OFFICIAL AGENDA
STARKVILLE TREE ADVISORY BOARD
CITY OF STARKVILLE, MISSISSIPPI
SPECIAL CALL MEETING OF WEDNESDAY, JANUARY 9, 2019
2ND FLOOR CITY HALL – COMMUNITY DEVELOPMENT,
110 West Main Street, 11:00 AM

STAFF REPORT

To: Members of the Starkville Tree Advisory Board
From: Daniel Havelin, City Planner (662-323-2525 ext. 3136)
Emily Corban, Assistant City Planner (662-323-2525 ext. 3138)
Subject: LW 19-01 Request for Landscape Waiver from Section 5 and 6 for the new
Powerstroke located at 310 Industrial Park Road in an M-1 zoning district with the
parcel number 102L-00-009.00
Date: January 9, 2019

Attachment 5- Enlarged Landscape Plan

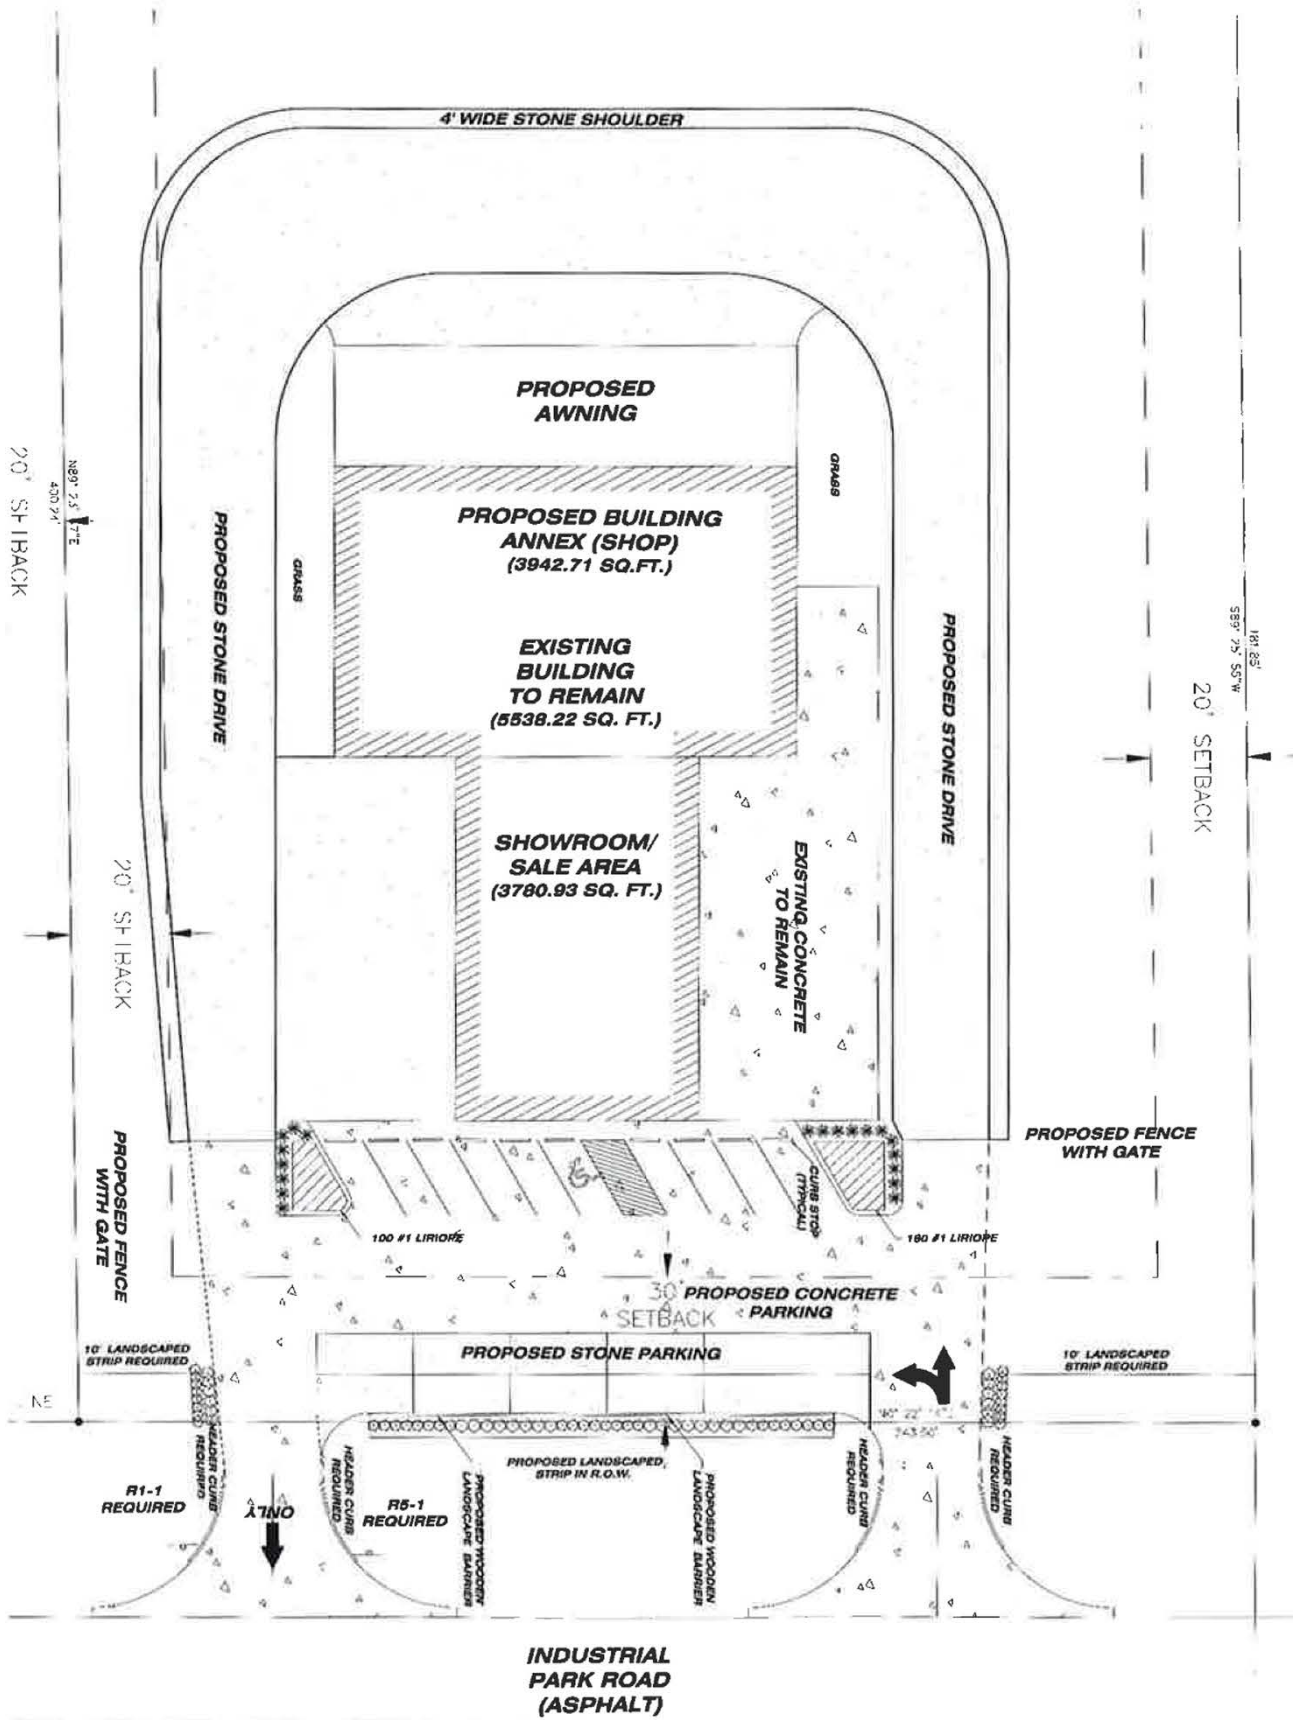
Request #1- Relief from the requirement to have a 10' landscape strip along the road frontage of the parking lot. The applicant is requesting to have the required landscape strip extend into the right of way of the road. This would allow for an increase to the trailer parking for customers. *Section 112-30, Section 5- (a)*

Request #2- Relief from the requirement to place canopy trees in the landscape strip along the roadway frontage. There were no trees shown in the proposed bed on the site plan. It was incorrectly listed on the plan that canopy trees would not be required due to existing trees on the site. Existing trees do not count toward this requirement and cannot be used by right as a substitution. *Section 112-30, Section 5- Table 5.1 (subtext)*

Request #3- Relief from the requirement to place a canopy tree in the interior parking area. 1 canopy tree is required per 200 square feet of bed area. No trees are shown in required interior parking islands. *Section 112-31, Section 6- (a) (3)*

Request #4- Relief from the requirement to place a landscape area at the end of each row of parking. This is for the area on the south side of the building. *Section 112-31, Section 6- (a) (2)*

Request #5- Relief from the requirement to place a landscape area on the perimeter of the parking area that includes shrub screen and canopy trees. *Section 112-31, Section 6- (b) (1) and table 6.2*
